**ENVIRONMENTAL REVIEW COMMITTEE REPORT AND  
ADMINISTRATIVE SITE DEVELOPMENT PLAN REPORT & DECISION**

<b>ERC MEETING DATE:</b>	December 1, 2014
<b>Project Name:</b>	149 Park Avenue North (Puget Sound Regional Services)
<b>Owner:</b>	Puget Sound Regional Services, 149 Park Avenue North, Renton, WA 98057
<b>Applicant/Contact:</b>	David Heinen, Barking Dog Design, 3722 West Armour Place, Seattle, WA 98199
<b>File Number:</b>	LUA14-001415, ECF, MOD, SA-A
<b>Project Manager:</b>	Clark H. Close, Associate Planner

**Project Summary:** The applicant proposes to remodel the second floor of a two-story building located at 149 Park Avenue North. The building is presently used for offices on the first floor and five (5) apartments on the second floor. The grade level will remain unchanged with current business/office use and the second level will be converted from existing apartments to office use. The existing building footprint size is 4,575 square feet (sf) and has a lot coverage of 40.5%. The parcel size is 11,288 sf. The project is located in the Commercial Corridor (CC) land use designation and the Commercial Arterial (CA) zoning classification. Access to the site is from either Park

**EXHIBIT 14**

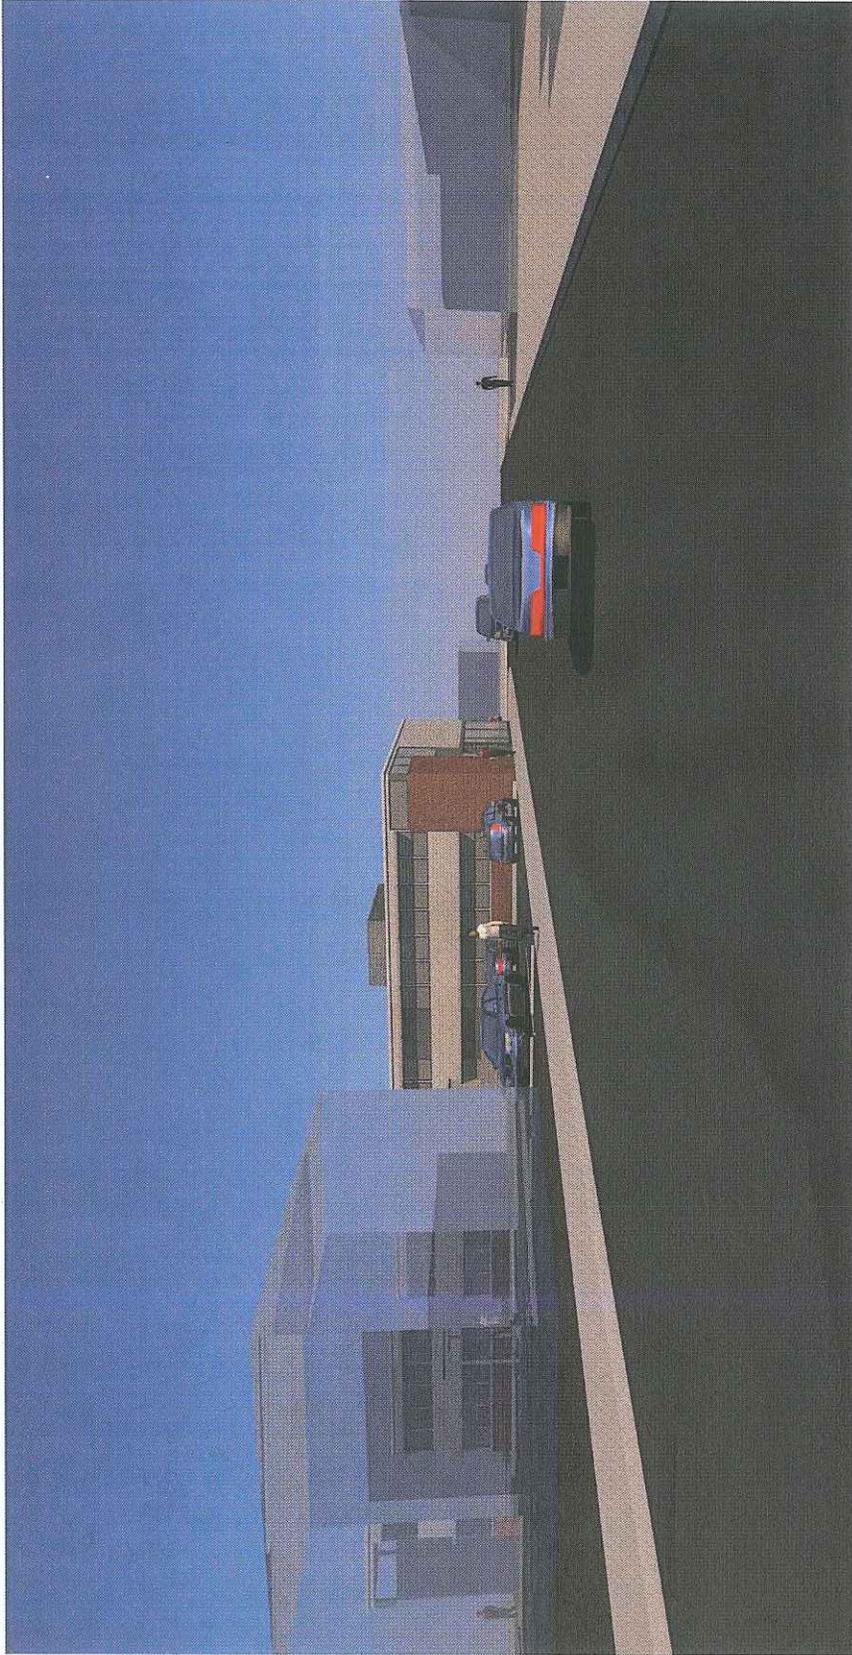
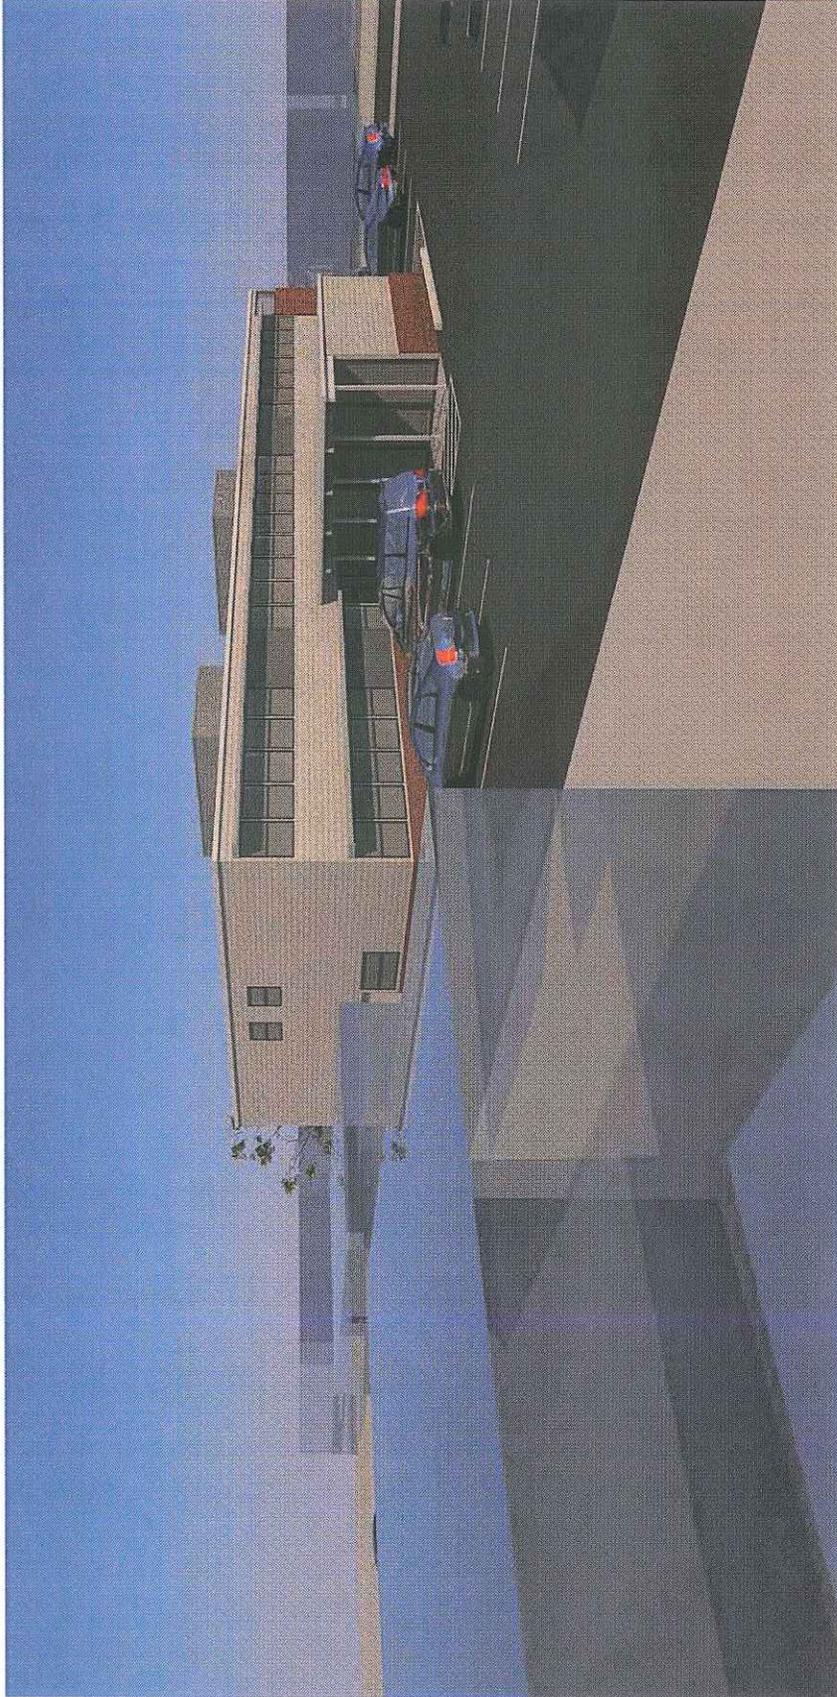
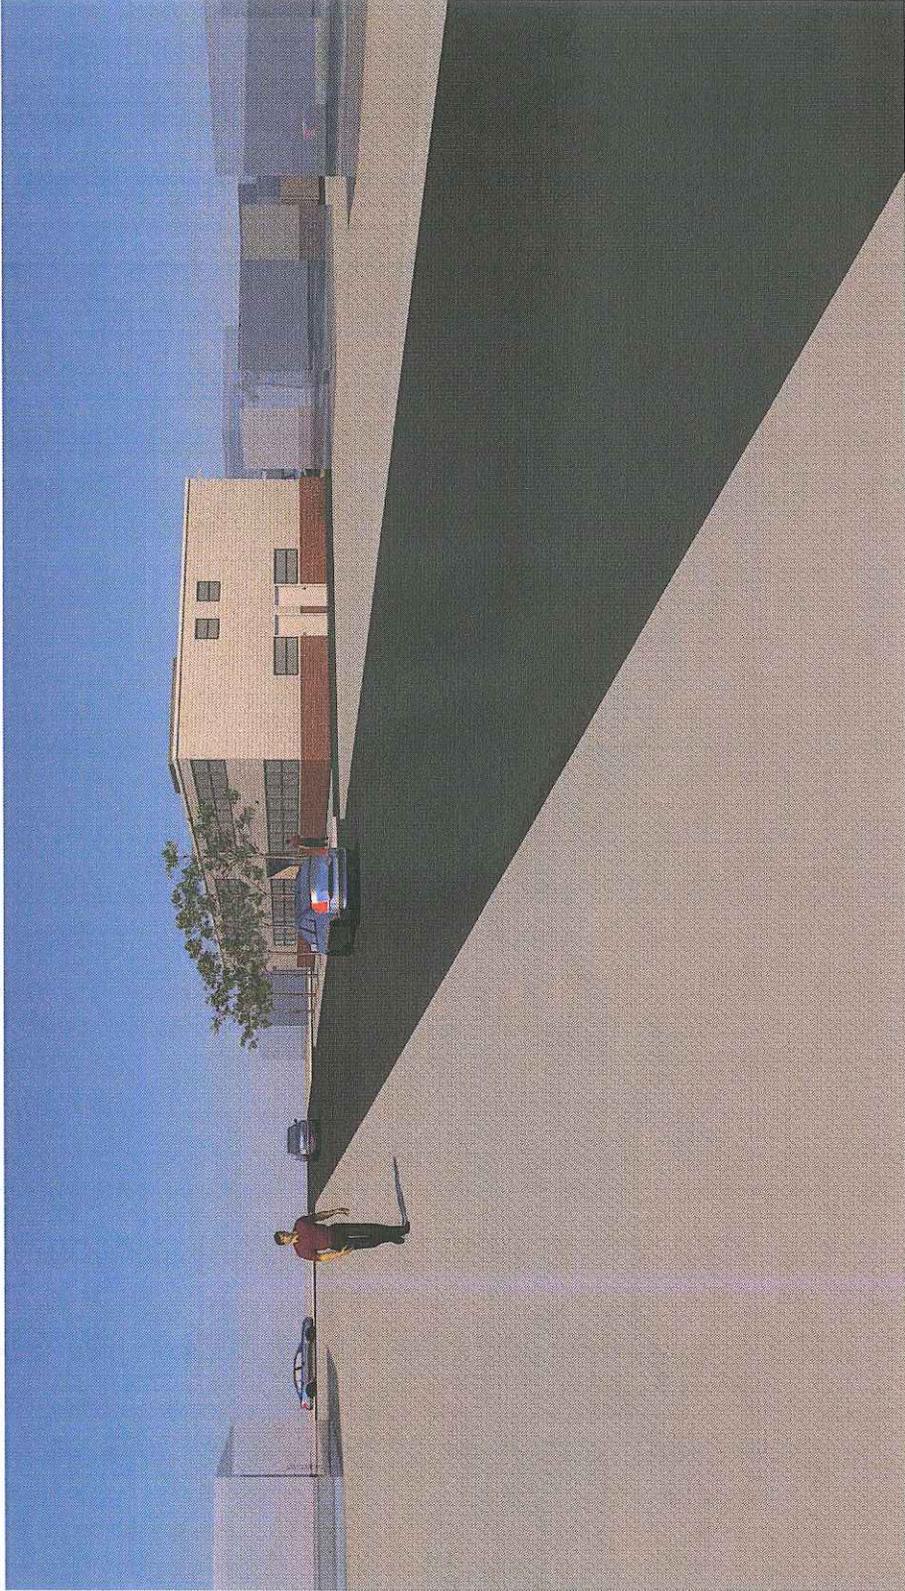
As part of the tenant improvements, a new rooftop mechanical equipment and screening will be added. The screening will extend approximately 4 feet (4') above the surface of the rooftop. The applicant has provided 3D renderings of the building, from various angles, in order to visualize the impacts of the proposed rooftop equipment and its screening (*Exhibit 14*).
